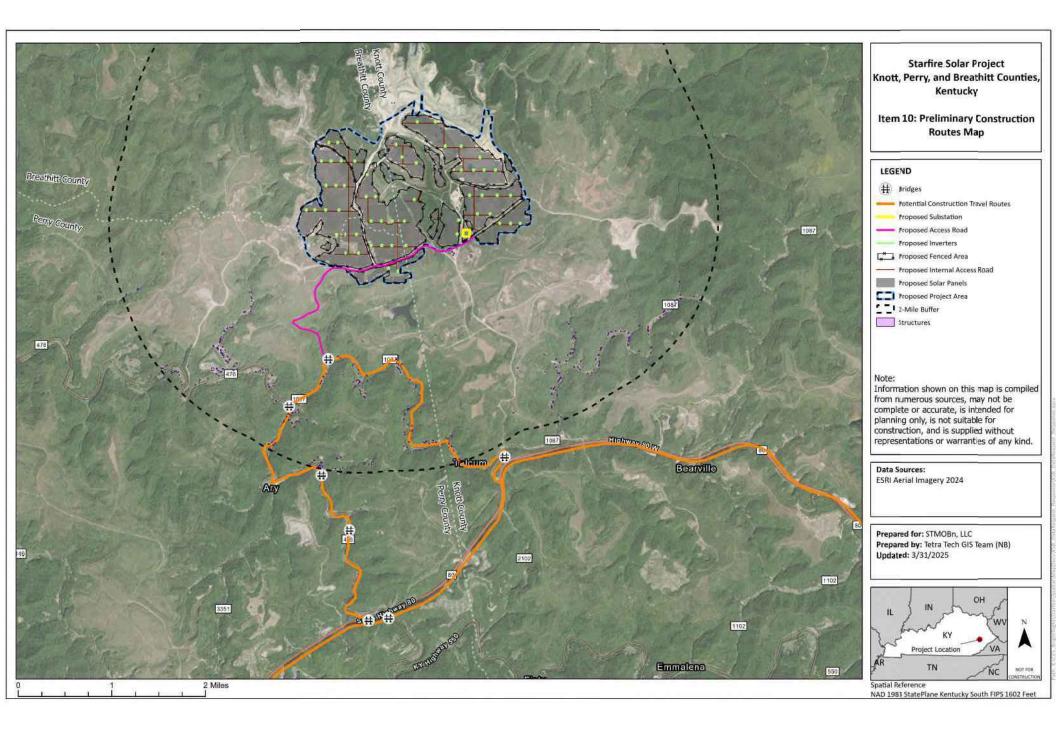
Provide a one-page directional map showing highlighted anticipated delivery routes for the project. Include on the map: access roads, access points, existing roads, bridges, electric generation components, and all structures within two miles of the project.

See attached.

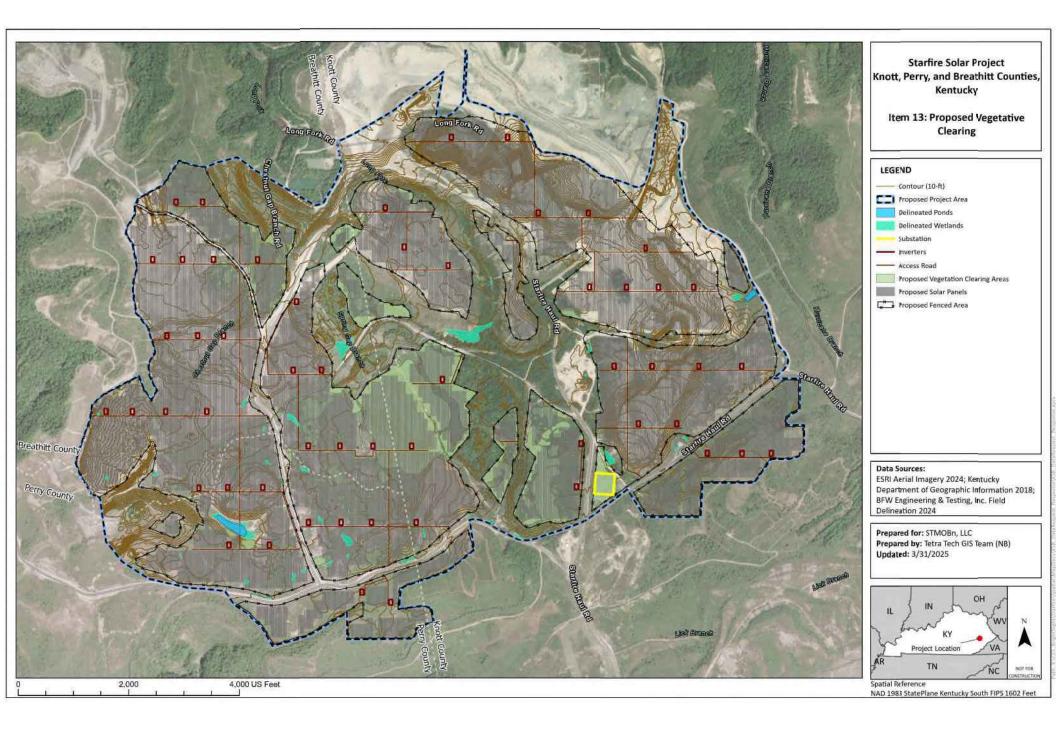
Provide a map showing all planned areas of vegetative clearing. Include on the map satellite imagery, wetland features, and elevation contours.

See attached.

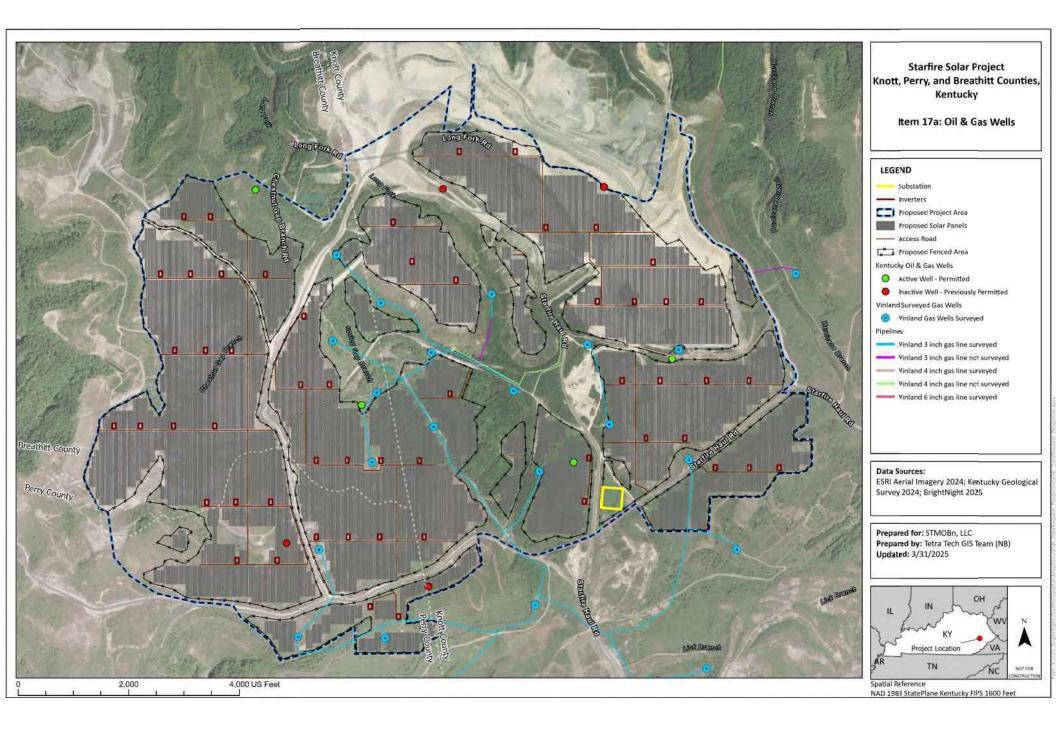
a. File a map identifying all active and inactive oil or gas wells on the proposed site.Also include any gas-gathering pipelines associated with the wells.

b. Determine and explain whether any of these wells are currently permitted and active. If active, identify the wells as such on the map provided in response to Item 17(a).

c. Explain whether the existence of oil and gas wells and pipelines will require adjustments to the proposed location of solar panels.

a. See attached.

b. See map provided in response to 17(a) for any currently permitted and active wells based on the KGS website.

c. There is at least one well that may require adjustments to the proposed location of panels. It is anticipated that some wells may be inactive by the time construction commences. Project representatives plan to communicate with well owners regarding these well locations within the next several months.

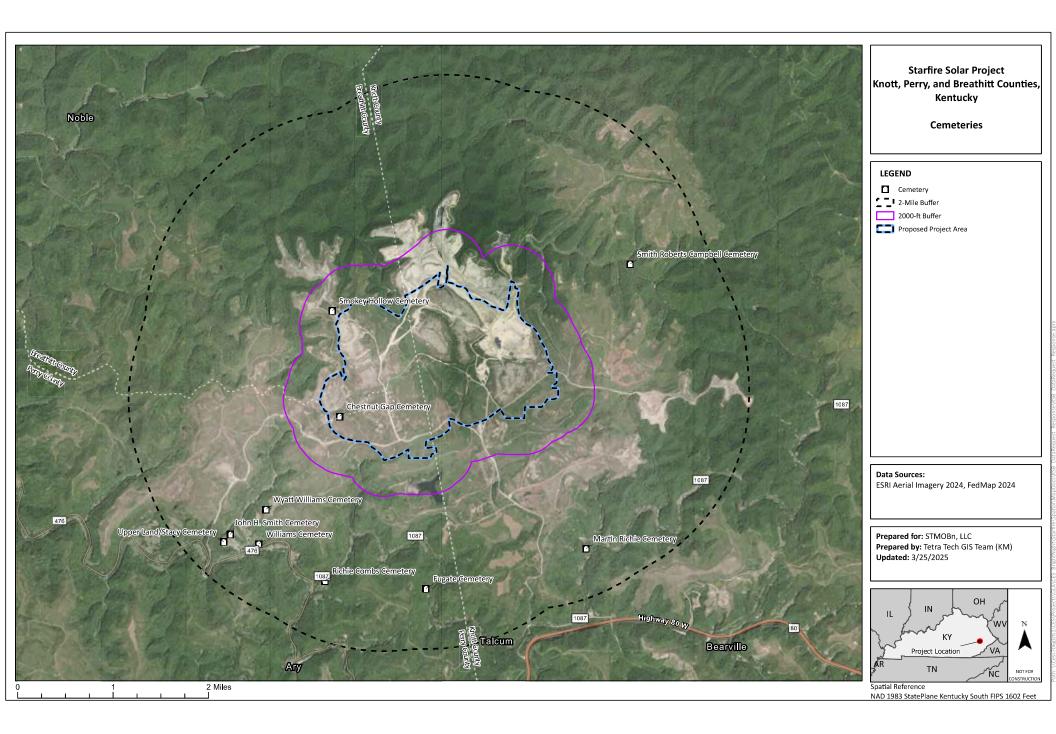
Identify all cemeteries located within a two-mile radius of the project on a map and identify if the project will restrict access to them in any way.

See attached. Nine cemeteries have been identified within two miles of the Project. Of these, two cemeteries may be subject to restricted access: Chestnut Gap Cemetery, located within the Project boundary; and Smokey Hollow Cemetery, which is located outside the boundary but within 2,000 feet of the Project site. The remaining seven cemeteries will not be subject to restricted access: Williams Cemetery, Smith Robers Campbell Cemetery, Upper Land/Stacy Cemetery, Wyatt Williams Cemetery, Richie Combs Cemetery, Martin Richie Cemetery, and John H. Smith Cemetery.

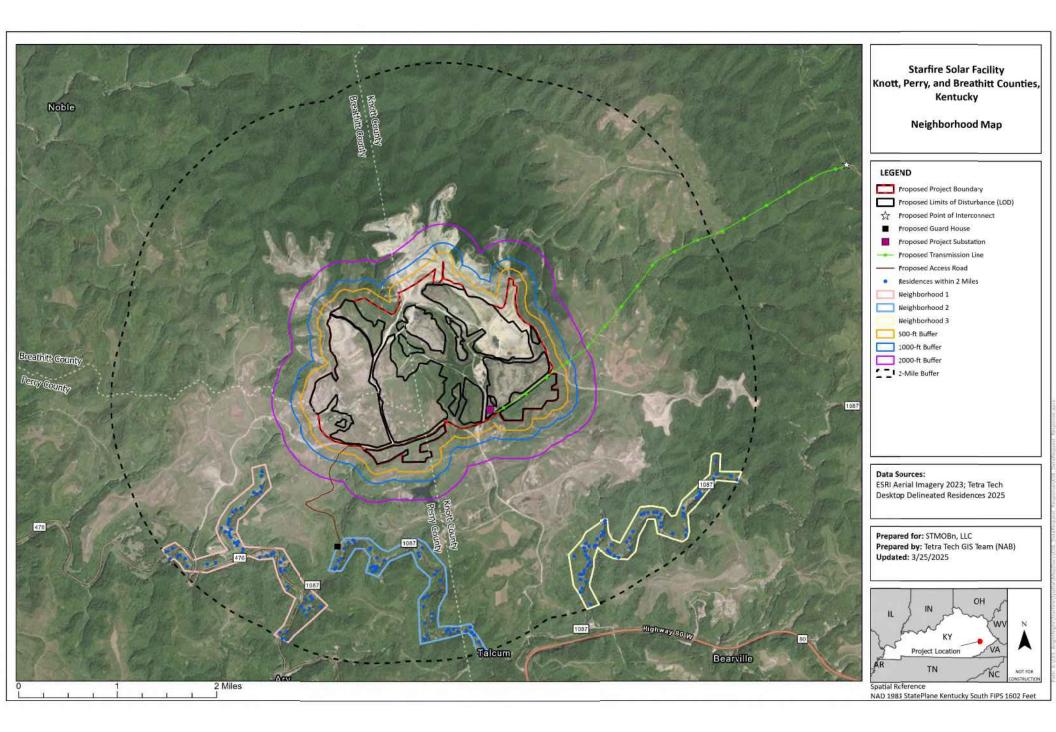
Refer to Application Exhibit A, "Neighborhood Map." Supplement this exhibit with the following information with adequate resolution for review:

a. Site access road(s) from nearest public roadways and locations of guard house(s)

- b. Location of proposed project substation.
- c. Location of proposed transmission line to point of interconnection.

- a. See attached.
- b. See Response 62(a).

c. See Response 62(a) (as anticipated for the proposed/preliminary route and to be approved in separate application to the Siting Board).
